Clause 162 Comments

IEEE P802.3ck Task Force

July 2020

Cable Assembly COM

D1.2 Page 154

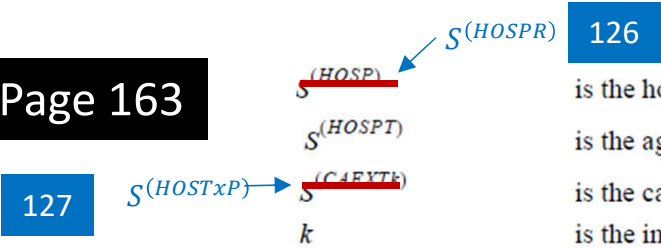
CA COM Channel (2)

- a) The channel signal path is $SCHS_p = \text{cascade}(S^{(CTSP)}, S^{(HOSP)}, S^{(HOSPR)})$, where $\text{cascade}()$ is defined in 93A.1.2.1, $S^{(HOSP)}$ is defined in 162.11.7.1.1, and $S^{(CTSP)}$ is the measured channel between the test references in Figure 110–3b.
- b) The COM parameters are as modified by Table 162–13.

$S^{(HOSPR)}$ 220
